**DEPARTMENT OF TRANSPORTATION**  
 DIVISION OF ENGINEERING SERVICES  
 Office of Structural Materials  
 Quality Assurance and Source Inspection

## QUALITY ASSURANCE -- NON-CONFORMANCE REPORT

**Report No:** NCR-000626

**Job Name:** SAS Superstructure  
**Document No:** 05.03.06-000589

项目名称 Project Name:	美国海湾大桥 SFOBB	部件图号 Drawing No.:	BK1	报告编号 Report No.:	B-CWR102
合同号 Contract No.:	04-0120F4	部件名称 Item Name:	DBG CANTILEVER BOX BRACKET	NDT 报告编号 NDT Report No.:	B787-MT-174
项目编号 Project No.:	ZP06-787

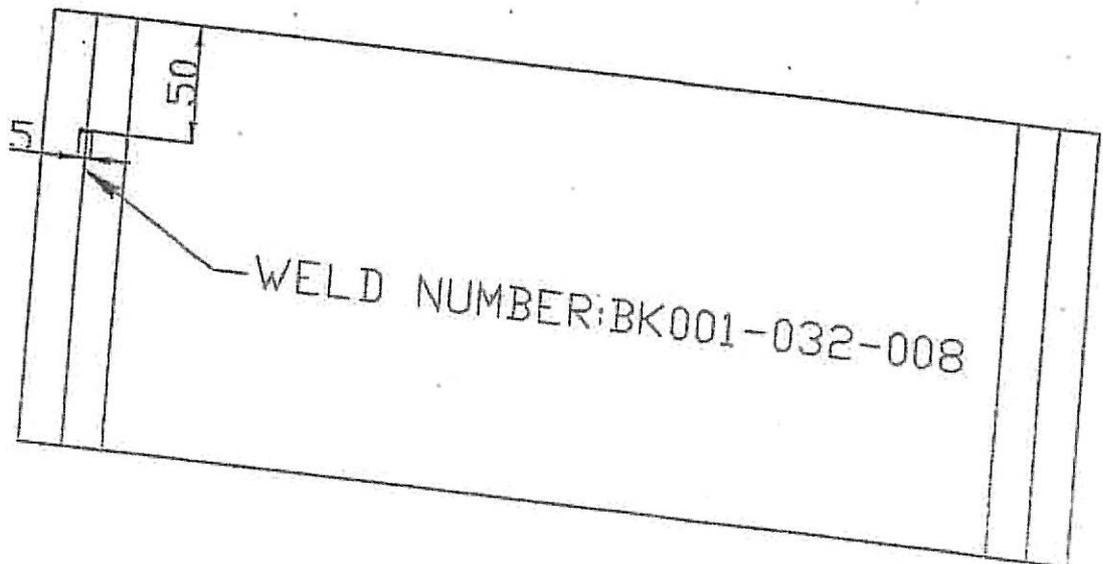
One transverse crack was found by use of MT on BK001-032-008.

2. QC and a Lead CWI shall have an approved copy of the CWR in hand prior to the repair.
3. Remove paint  $\geq 25$ mm in all direction of HAZ prior to MT.

6. Prepare excavation in accordance with the New Repair Procedure prior to welding.
7. Before this repair, Verify with VT and MT repair areas are defects free, and also MT shall be performed on the base metal laying abroad cracks to ensure that no cracks were propagated to the base metal. Separate CWR approval is needed if cracks are found in the base metal, and only after this new CWR's approval can continue the repair.

项目名称 Project Name	美国海湾大桥 SFOBB	部件图号 Drawing No	CB202A	报告编号 Report No.	B-WR10060
合同号 Contract No.	04-0120F4	部件名称 Items Name	CB16 STRUT	NDT报告编号 Report No. of NDT	B787-UT-10854
项目编号 Project No.:	ZP06-787

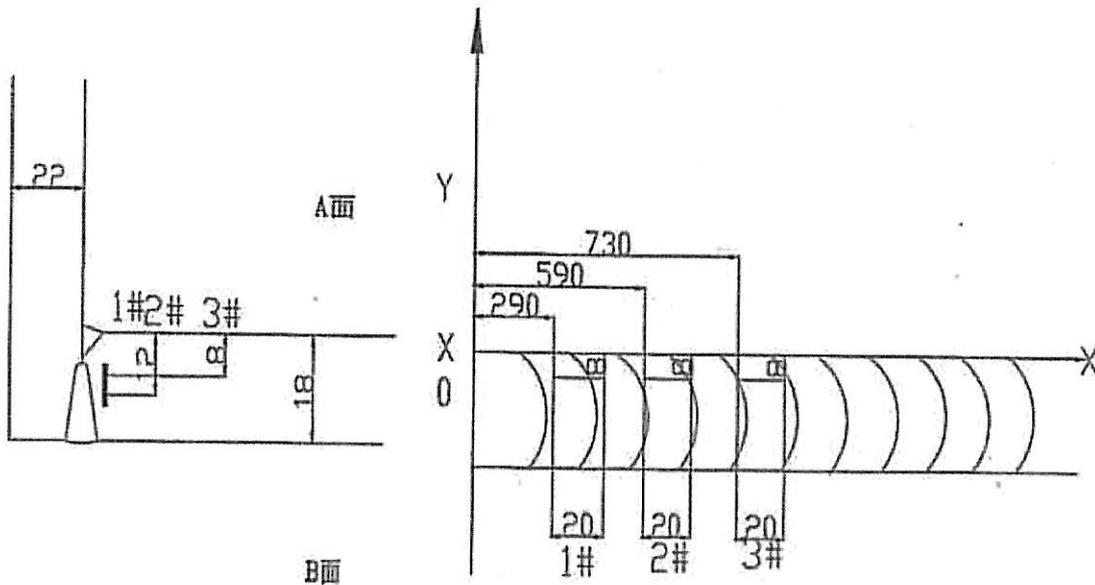
Rejected indication found by ultrasonic inspection is less than the maximum allowance aggregate length.

1. 从缺陷距离端面较近一侧 ( $D \leq 0.65T$ , D为缺陷深度, T为板厚) 采用碳锉或打磨的方法去除焊缝缺陷;
  2. 参照返修焊接工艺规程 (WPS) 准备正确的接头型式, 预热和焊接;
  3. 焊前对修补区域进行VT检测保证缺陷完全被清除;
  4. 将修补区域打磨到与母材或邻近焊缝平齐;
  5. 根据批准的车间图纸检查焊缝.
- 
1. Gouge or grind from nearer side from metal edge ( $D \leq 0.65T$ , "D" is depth of defects, "T" is thickness of metal) to remove all defects;
  2. Follow repair WPS for joint preparation, preheat, and weld deposit;
  3. Verify with VT no defects remain in the weld joint prior to welding;
  4. Grind the repaired area flush with base metal or the adjacent weld;
  5. Check the welds according to the working drawings;

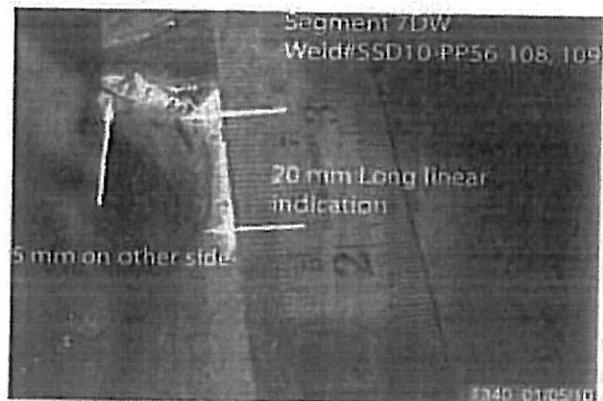
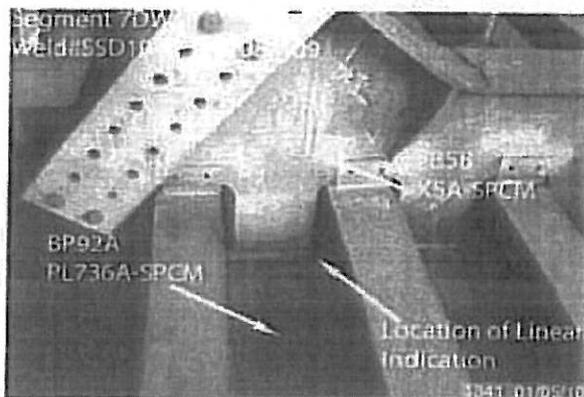
- One (1) Longitudinal linear indication measuring approximately 20mm in length.

- The welds are identified as: SSD10-PP56-108, 109.

- These welds are a Fillet Weld type joining the Bottom Plate (BP92A) to Floor Beam (FB5B) web plate.

- These welds are designated as Seismic Performance Critical Member (SPCM) on the approved drawing (SEGSD10).

项目名称 Project Name:	美国海湾大桥 SFOBB	部件图号 Drawing No.:	SSD10	报告编号 Report No.:	E-CWR1043
合同号 Contract No.:	04-0120F4	部件名称 Item Name:	OBG FLOOR BEAM AND BOTTOM PLAT E	NDT 报告编号 NDT Report No.:	B787-MT-17605
项目编号 Project No.:	ZP06-787

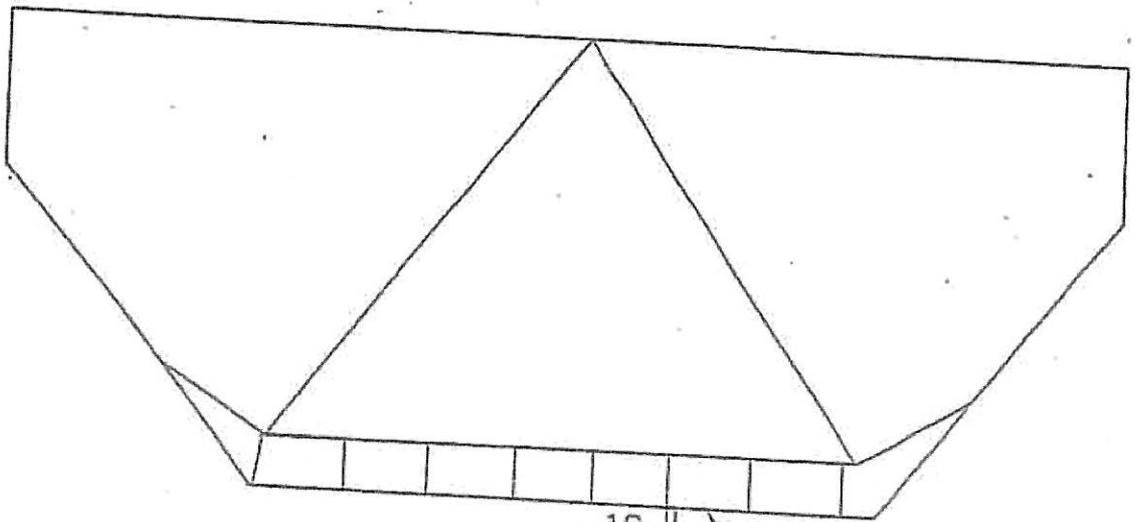
One longitudinal crack was found by use of MT on SSD10-PP56-108.

- 2. QC and a Lead CWI shall have an approved copy of the CWR in hand prior to the repair.
- 3. Remove paint ≥25mm in all direction of HAZ prior to MT.
- 4. Clean the excavation area of all loose debris including MT powder. Preheat to 65° C before removing cracks by grinding, repair area shall extend a minimum of 50mm beyond each end of single crack repairs.

- 6. Prepare excavation in accordance with the New Repair Procedure prior to welding.
- 7. Before this repair, Verify with VT and MT repair areas are defects free, and also MT shall be performed on the base metal laying abroad cracks to ensure that no cracks were propagated to the base metal. Separate CWR approval is needed if cracks are found in the base metal, and only after this new CWR's approval can continue the repair.

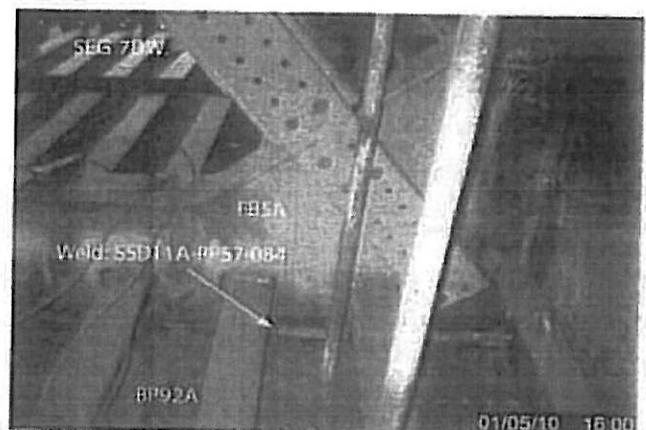
One (1) longitudinal linear indication measuring approximately 10 mm in length.

-The member is identified as FL2-2 Floor Beam FB005-025

-The weld is a fillet weld T-joint, joining FB005-025 to Seismic Performance Critical Material (SPCM) bottom panel identified as BP092A.

-The weld is identified as SSD11A-PP57-084.

-The approved shop drawings, detail this weld as a Fracture Critical Weld (FCW).

项目名称 Project Name:	美国海湾大桥 SFOBB	部件图号 Drawing No.:	SSD11	报告编号 Report No.:	B-CWR1044
合同号 Contract No.:	04-0120F4	部件名称 Item Name:	OBG FLOOR BEAM AND BOTTOM PLAT E 7DW	NDT 报告编号 NDT Report No.:	B787-MT-1760
项目编号 Project No.:	ZP06-7B7

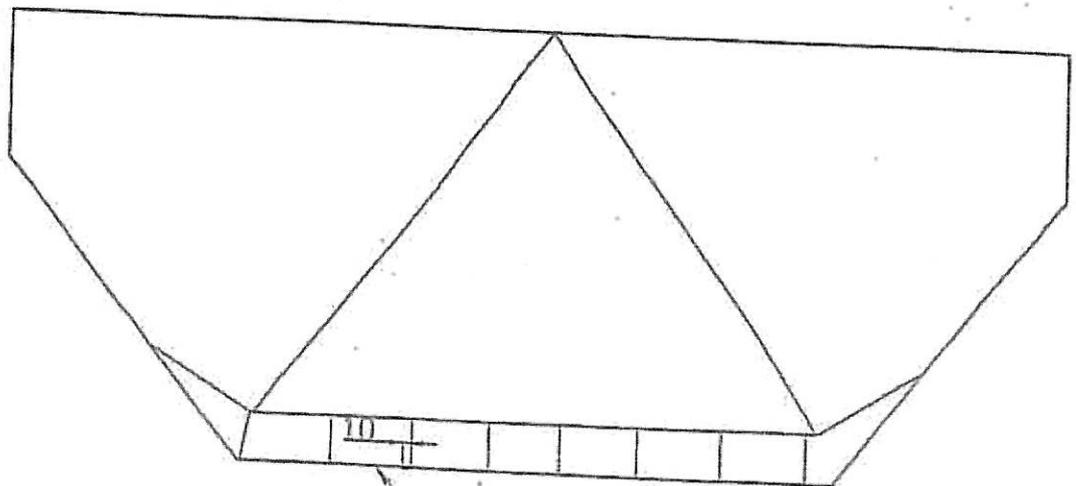
One longitudinal crack was found by use of MT on SSD11-PP57-0B4.

2. QC and a Lead CWI shall have an approved copy of the CWR in hand prior to the repair.
3. Remove paint  $\geq 25$ mm in all direction of HAZ prior to MT.

6. Prepare excavation in accordance with the New Repair Procedure prior to welding.
7. Before this repair, Verify with VT and MT repair areas are defects free, and also MT shall be performed on the base metal laying abroad cracks to ensure that no cracks were propagated to the base metal. Separate CWR approval is needed if cracks are found in the base metal, and only after this new CWR's approval can continue the repair.

项目名称 Project Name:	美国梅湾大桥 SFOBB	部件图号 Drawing No.:	SSD11	报告编号 Report No.:	B-CWR1
合同号 Contract No.:	04-0120F4	部件名称 Item Name:	BCW FLOOR BEAM SPLICE	NDT 报告编号 NDT Report No.:	B787-MT-1
项目编号 Project No.:	ZP06-787

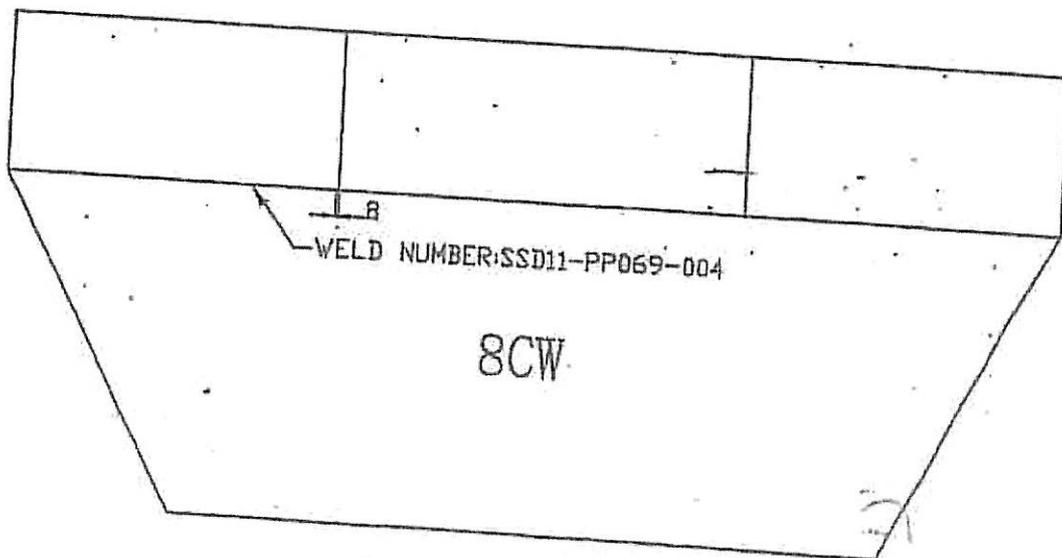
One longitudinal crack was found by use of MT on SSD11-PP69-004.

2. QC and a Lead CWI shall have an approved copy of the CWR in hand prior to the repair.
3. Remove paint  $\geq 25$ mm in all direction of HAZ prior to MT.

6. Prepare excavation in accordance with the New Repair Procedure prior to welding.
7. Before this repair, Verify with VT and MT repair areas are defects free, and also MT shall be performed on the base metal laying abroad cracks to ensure that no cracks were propagated to the base metal. Separate CWR approval is needed if cracks are found in the base metal, and only after this new CWR's approval can continue the repair.

项目名称 Project Name:	美国海湾大桥 SFOBB	部件图号 Drawing No.:	SEG039	报告编号 Report No.:	B-CWR1167
合同号 Contract No.:	04-0120F4	部件名称 Item Name:	DBG DECK PLATE SPlice 7BW	NDT 报告编号 NDT Report No.:	B787-MT-18475
项目编号 Project No.:	ZP06-787

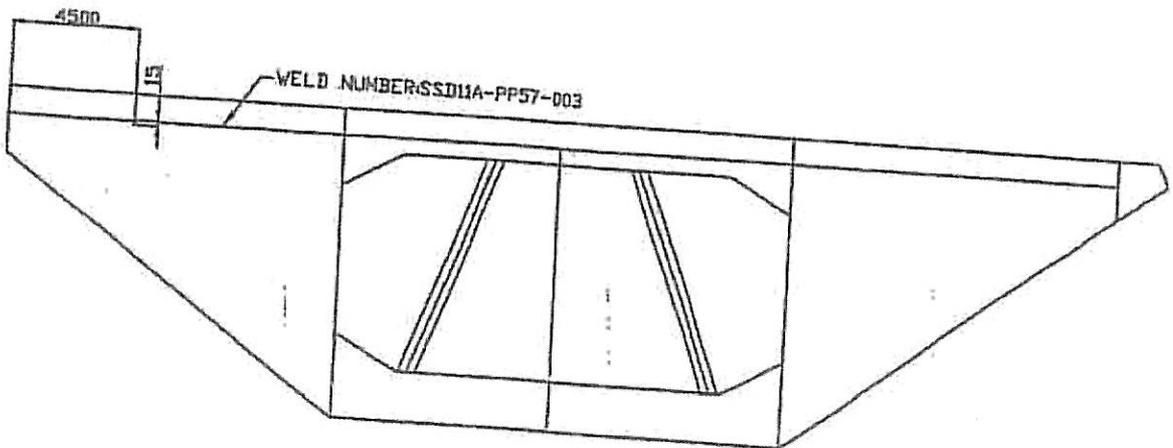
One transverse crack was found by use of MT on SSD11A-PP57-003.

2. QC and a Lead CWI shall have an approved copy of the CWR in hand prior to the repair.
  3. Remove paint  $\geq 25$ mm in all direction of HAZ prior to MT.

7. Before this repair, Verify with VT and MT repair areas are defects free, and also MT shall be performed on the base metal laying around cracks to ensure that no cracks were propagated to the base metal. Separate CWI approval is needed if cracks are found in the base metal, and only after this new CWR's approval can continue the repair.

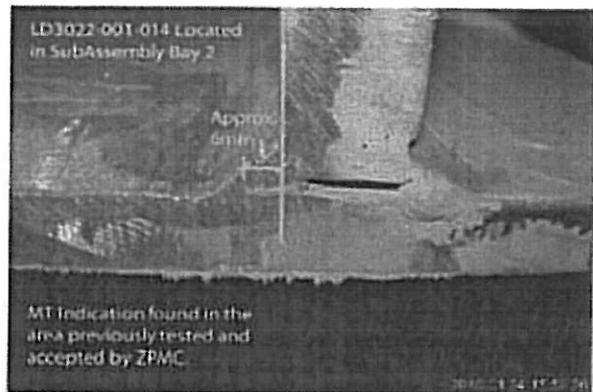
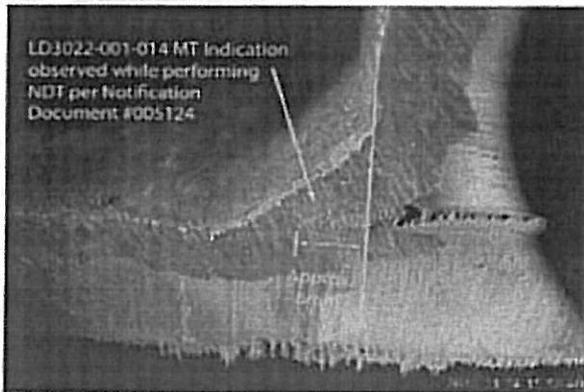
Reference Description: Missed MT Indication by QC for a weld joint on the Lift 12 Longitudinal Shear Plate

项目名称 Project Name:	美国海湾大桥 SFOBB	部件图号 Drawing No.:	LD3022	报告编号 Report No.:	B-CWR1151
合同号 Contract No.:	04-0120F4	部件名称 Item Name:	12 <sup>th</sup> lifting longitudinal diaphragm	NDT 报告编号 NDT Report No.:	B787-MT-17930
项目编号 Project No.:	ZP06-787

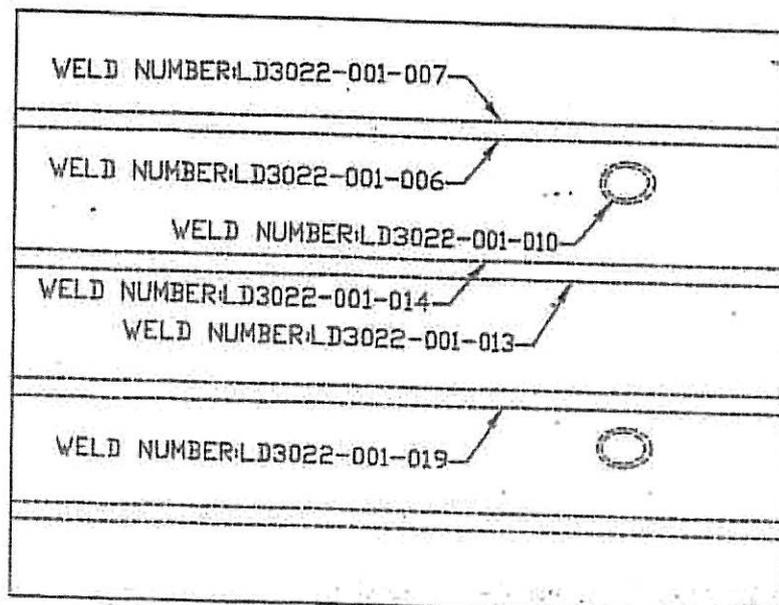
One pore and two transverse cracks were found by use of MT on LD3022-001-006.  
One longitudinal crack and four transverse cracks were found by use of MT on LD3022-001-007.  
One pore and one transverse crack were found by use of MT on LD3022-001-010.  
One pore and two transverse cracks were found by use of MT on LD3022-001-013.  
One longitudinal crack and one transverse crack were found by use of MT on LD3022-001-014.  
One pore and one transverse crack were found by use of MT on LD3022-001-019.

2. QC and a Lead CWI shall have an approved copy of the CWR in hand prior to the repair.
3. Remove paint  $\geq 25$ mm in all direction of HAZ prior to MT.

6. Prepare excavation in accordance with the New Repair Procedure prior to welding.
7. Before this repair, Verify with VT and MT repair areas are defect free, and also MT shall be performed on the base metal laying abroad cracks to ensure that no cracks were propagated to the base metal. Separate CWR approval is needed if cracks are found in the base metal, and only after this new CWR's approval can continue the repair.
